TECHNICAL BULLETIN INDEX
Sorted by Bulletin Number
04/03/86

BULLETIN NO: II:1

PRODUCT: 26-4001/2 Model II

FIG 1

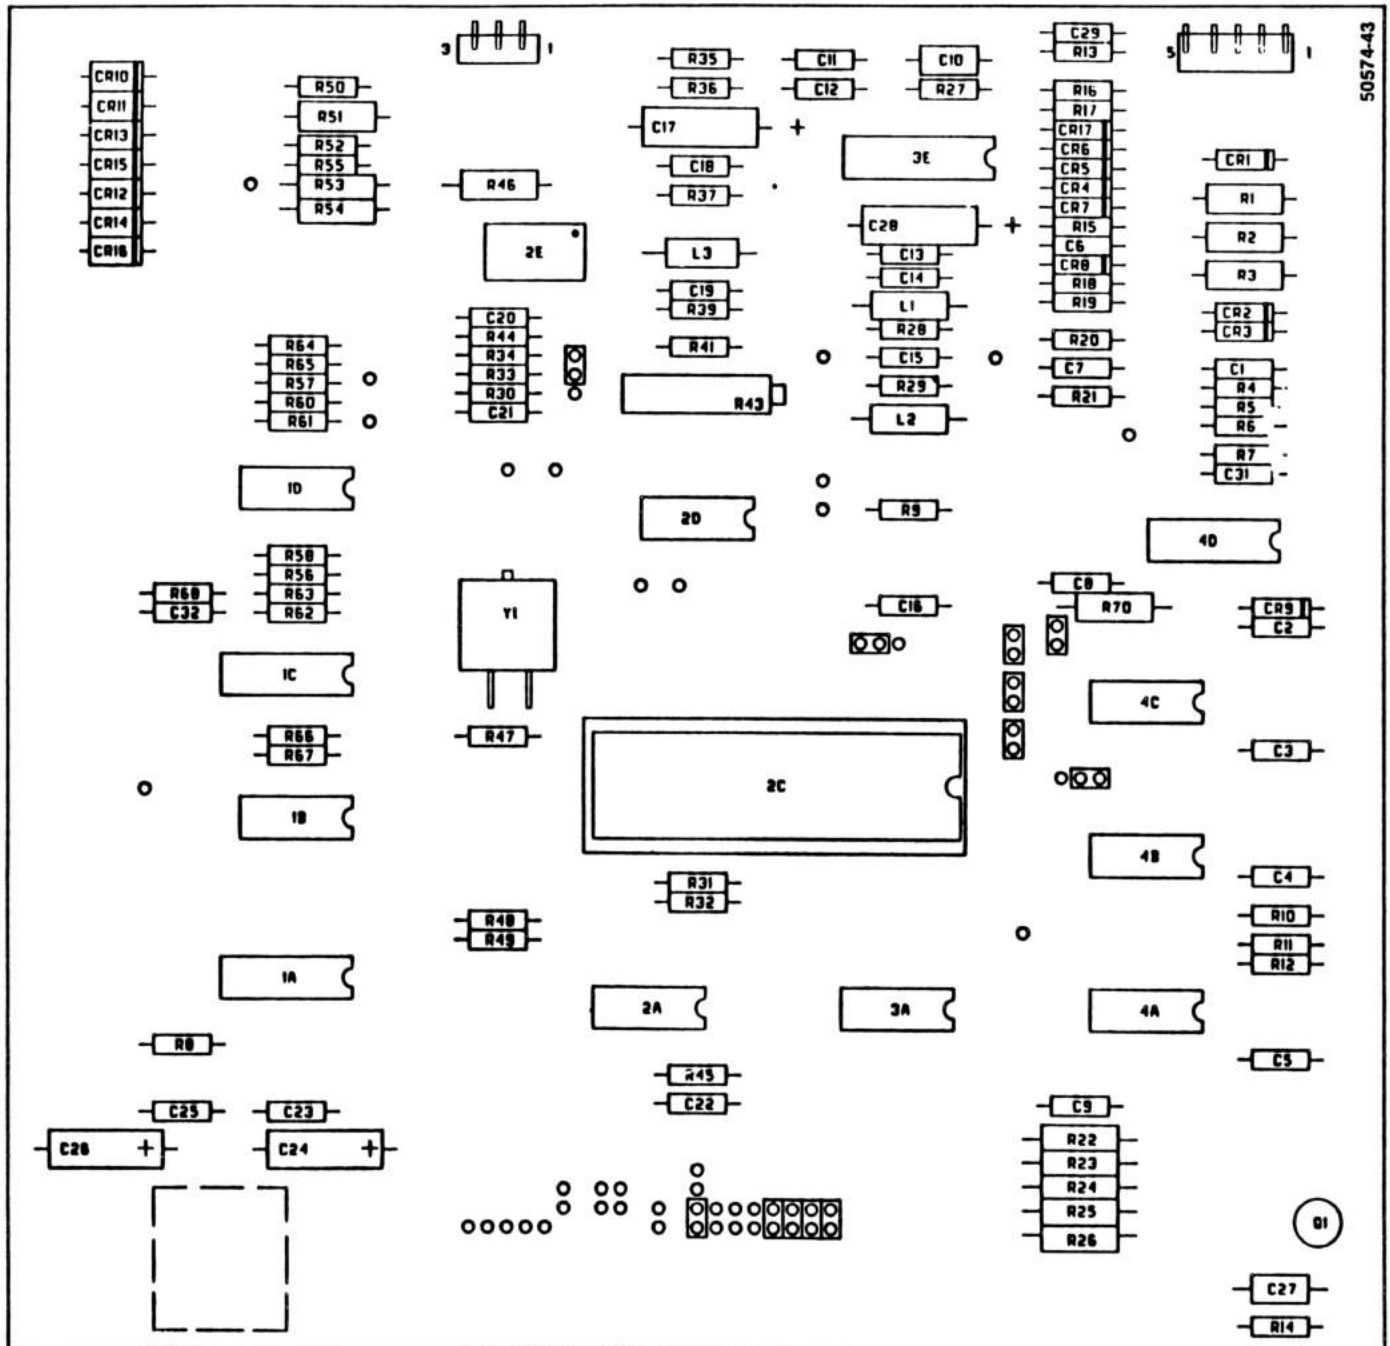
PURPOSE: To correct problem of getting Boot Error DC usually after running Scripsit.

PROCEDURE: SOLUTION 1: Check board to insure .47 ufd capacitor is installed across C21 (Refer to Figure 1). This capacitor should be on all LSI boards, if not present, install capacitor with negative lead going to ground. Any value from .47ufd to .68ufd is acceptable. ACC-474MGTP is the National Parts Number for a .47ufd 35V capacitor. Later boards had the capacitor value at C21 changed.

Figure 1

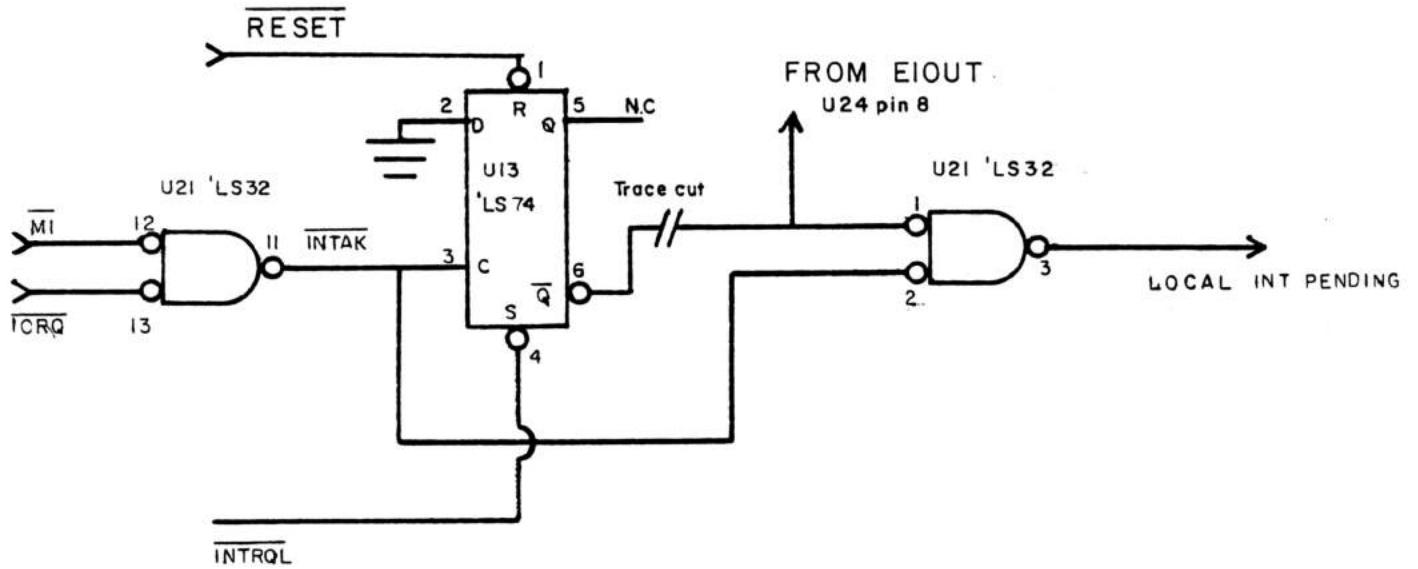
Refer to Figure 1 for schematic changes affected by this modification. The signal Local Interrupt Pending is now ANDed with EIOUT, and not with INTRQL. Previously, if the SIO programming was changed with interrupts disabled, a local interrupt could set flip-flop U13 without being serviced. Later, when an off board interrupt occurred, the bus steering logic would mistakenly interpret this as an on-board interrupt and would not turn the external data receive buffers. By ANDing the EIOUT signal with INTAK signal this problem is eliminated.

If the CPU board is a Rev A/B/C or no Rev letter, cut the trace on the back of the board between U13 pin 6 and U21 pin 1 and add a jumper wire between U21 pin 1 and U24 pin 8. Rev D, later Rev boards, and boards that have been modified for hard disk require NO cuts or jumper wires. However, the push on jumpers must be changed on all boards.

Figure 1

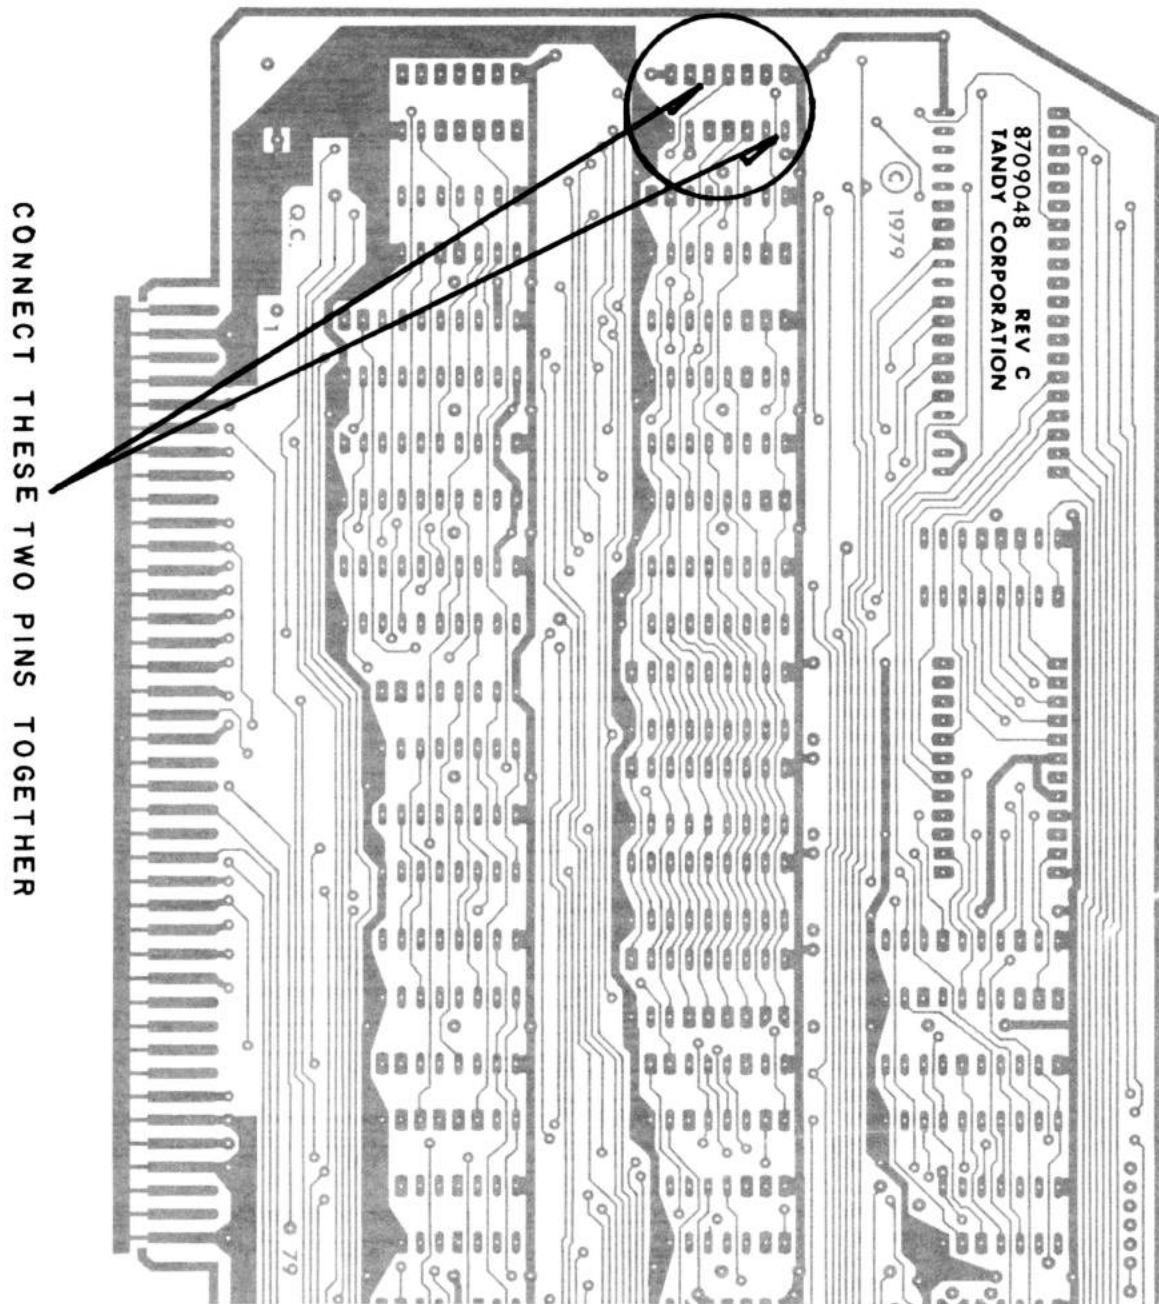
PURPOSE: To correct dual addressing on Video/Keyboard Interface boards (Rev A/B).

DISCUSSION: Rev A and B VDG boards have a problem with dual addressing. Addresses FC through FF are decoded on the VDG board for use by the Model II. There is an image of these addresses from 7C through 7F. Most systems will not have hardware port mapped at these addresses so no problem will appear. The only time a problem may arise is if a system has hardware installed that is port mapped in the range of 7C through 7F. This problem was corrected on Rev C VDG boards.

PROCEDURE: Whenever a Rev C VDG board is replaced with a Rev A or B VDG board jumper pin 1 to pin 10 of U27 on the Rev A or B board to insure no addressing conflict of the VDG board (Refer to Figure 1).

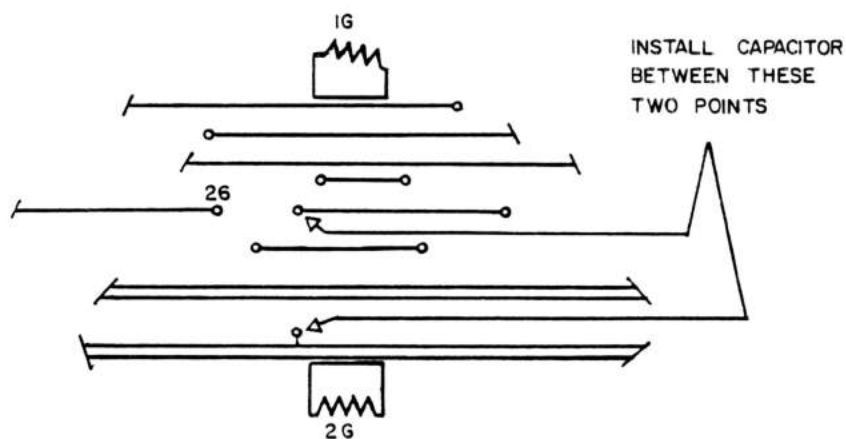
PURPOSE: To correct boot errors on systems with Shugart discrete logic boards installed.

DISCUSSION: To correct booting errors the Ready line on the Shugart discrete logic board should be bypassed to ground with a .01ufd disc capacitor. All discrete boards should have this capacitor installed as a preventive measure. Any system that exhibits an unexplained booting problem not related to a hardware fault should be checked for this capacitor. This is now being done at the factory to new discrete boards. This capacitor is NOT to be added to Shugart LSI logic boards.

PROCEDURE: Check Ready line for .01ufd installed to ground. If capacitor is not present install .01ufd disk capacitor to ground (Refer to Figure 1).

FIG 2

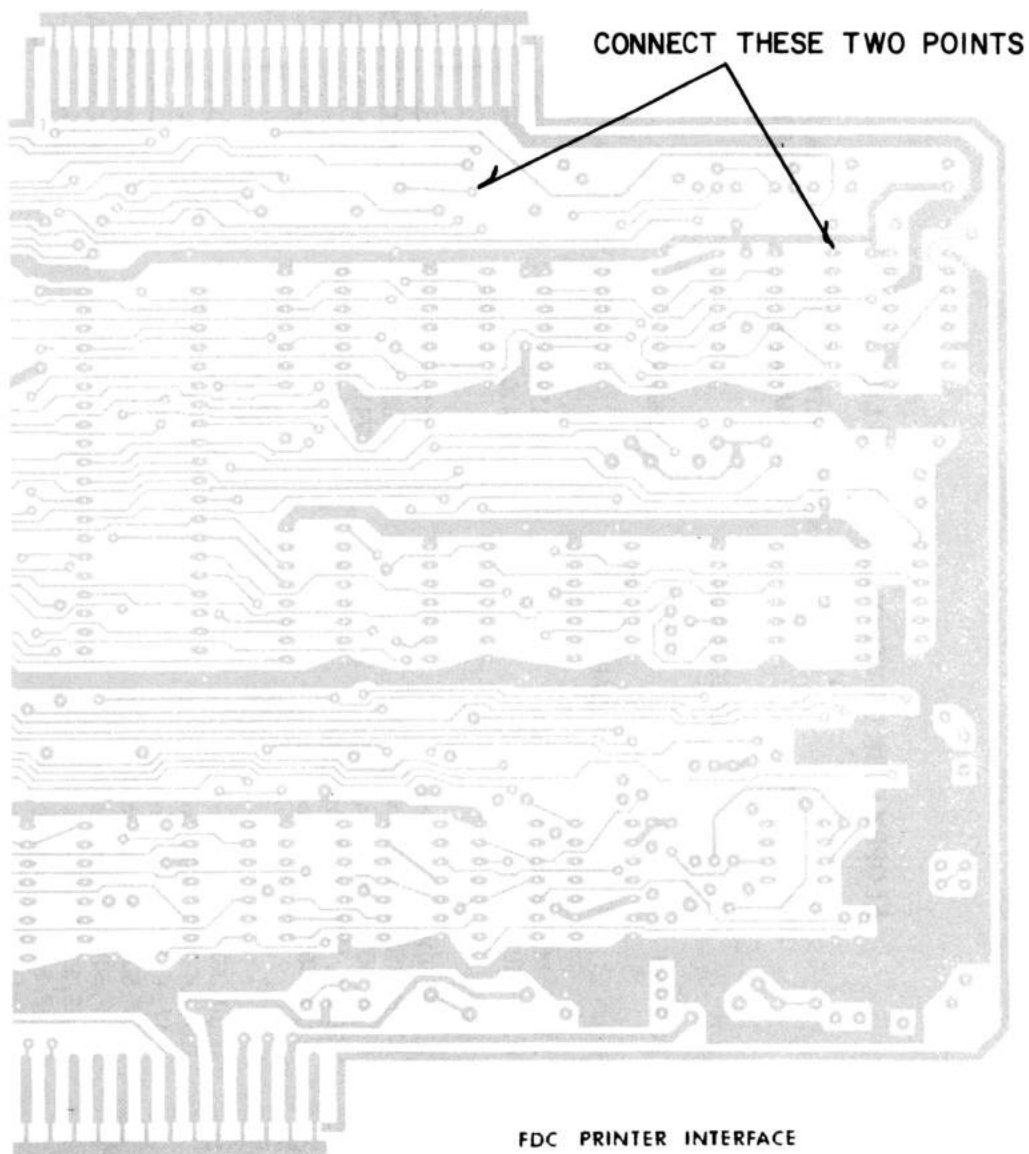
PURPOSE: To correct problem of not being able to format past Track 43.

DISCUSSION: Some early FDC boards may not be able to format past Track 43 with precomp set at the required specification of 250 nsec. This problem will occur ONLY with the SY1791-02 FDC chip (not the FD1791-02 FDC chip) because the EARLY pulse ends slightly sooner on the SY1791-02. This could lead to a double pulse being picked off the shift register. To correct this problem the data out is tied to the RESET of the shift register. As soon as the data triggers the one-shot, it then clears the shift register, preventing double data pulses (Refer to Figure 1).

PROCEDURE: On unmarked, Rev A, or Rev B boards make sure the "one shot" modification has been installed (Refer to Technical Bulletin II:9), or that long jumpers are installed on the back of the board running to U37. Disregard this step on Rev C and D boards as they have this modification incorporated into their circuitry. On ALL revisions of the current board with a SY1791-02 FDC chip installed, add a jumper wire on the back side of the board from U1 pin 1 to the trace connected to TP10 (Refer to Figure 2).

Figure 1

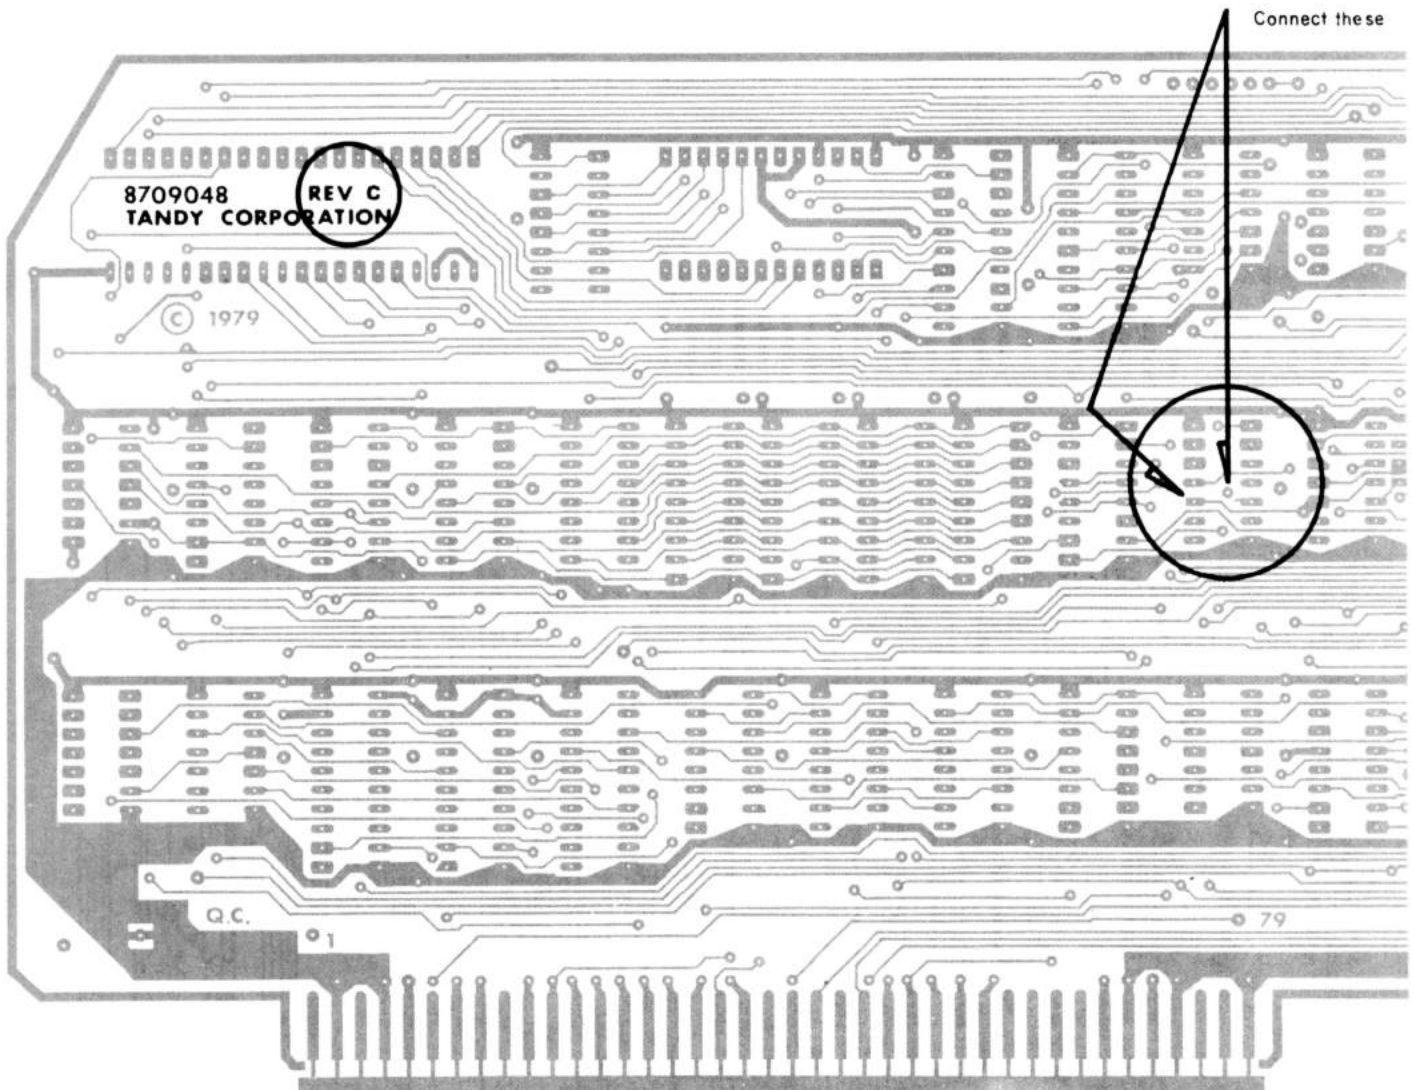
PURPOSE: To correct unexplained keyboard entries and/or machine lockup.

DISCUSSION: On Rev C VDG boards made by Lika there is a trace missing to the clear line on the latch (U17) that generates KBIRQ*. This can generate random interrupts that may or may not be fatal. To correct this problem a jumper is added to correct the missing trace which is a pullup to the clear line of U17. To identify the board as being manufactured by Lika, look for the Rev C marking on the solder side of the board under the 6845 chip and by LEI etched also on the solder side the crystal. This is the ONLY board to which this fix applies.

PROCEDURE: On the solder side of the board there is a feedthru located beneath the middle of U17 that is not connected to anything. Run a short piece of wire from that feedthru to U17 Pin 10 (Refer to Figure 1).

Figure 1

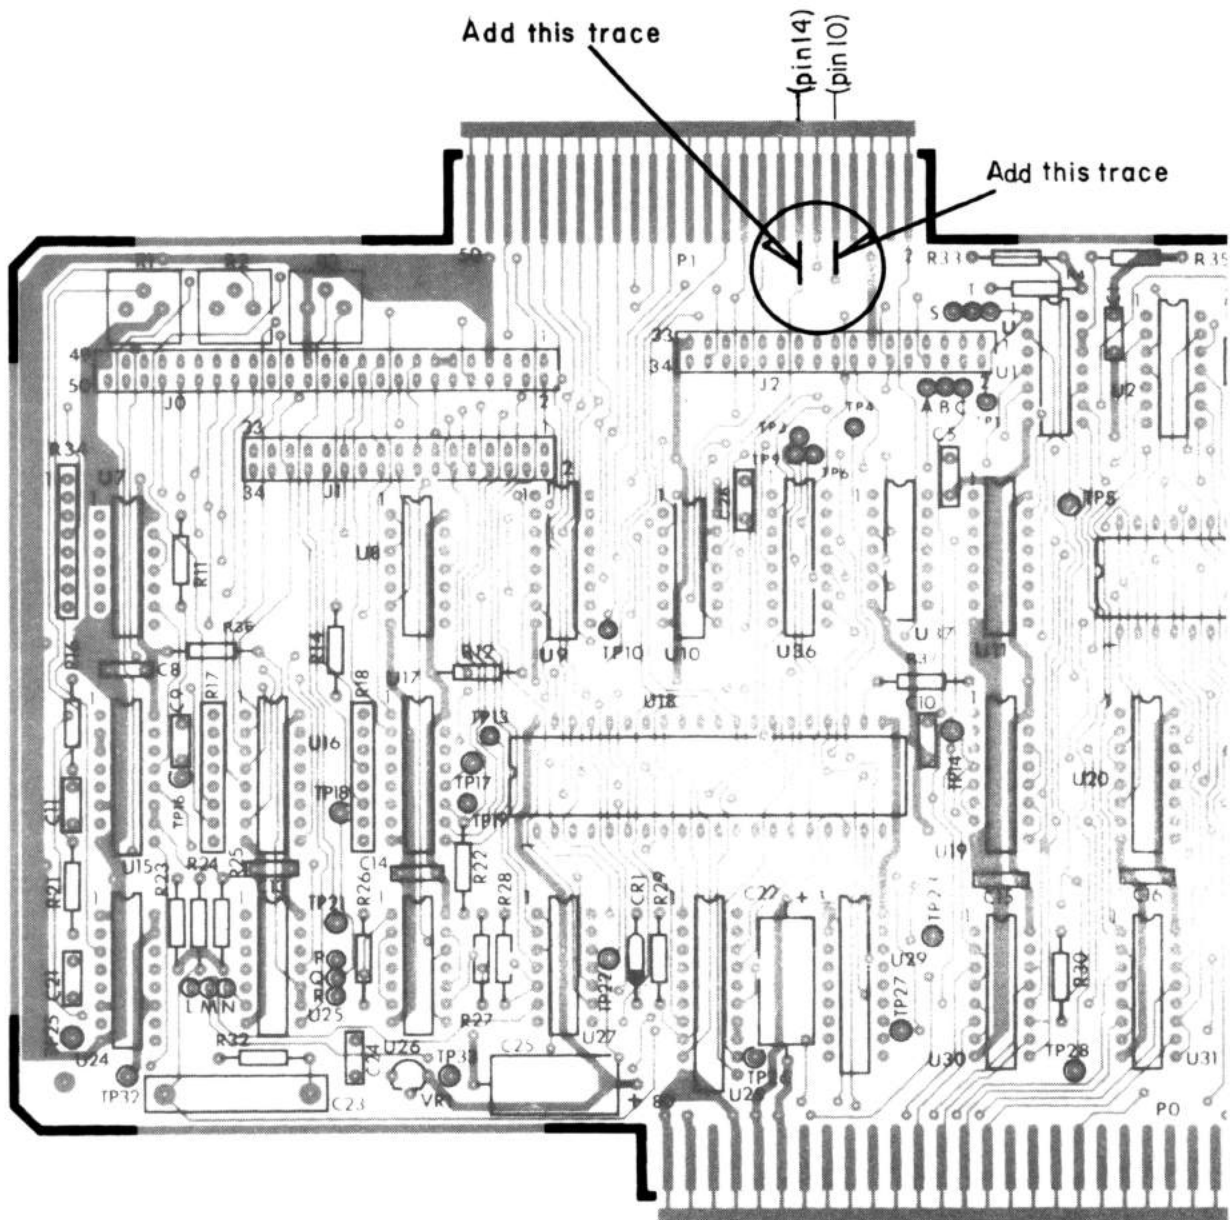
DISCUSSION: The trace that supplies the side select signal to the external drive connector on the Late Design FDC board (Rev Blank) is missing. Also, on some boards the trace that supplies the TWOSIDE* signal from the external drives to the FDC board is not present. Without these traces double sided drives cannot be used externally with the computer and will cause a problem with some diagnostics.

PROCEDURE: Refer to Figure 1 for the location of these traces. Run a jumper from pin 14 of connector P1 to the feedthru on the PCB that is directly in from the connector. Also run a jumper from pin 10 of connector P1 to the feedthru that is directly in from the connector.
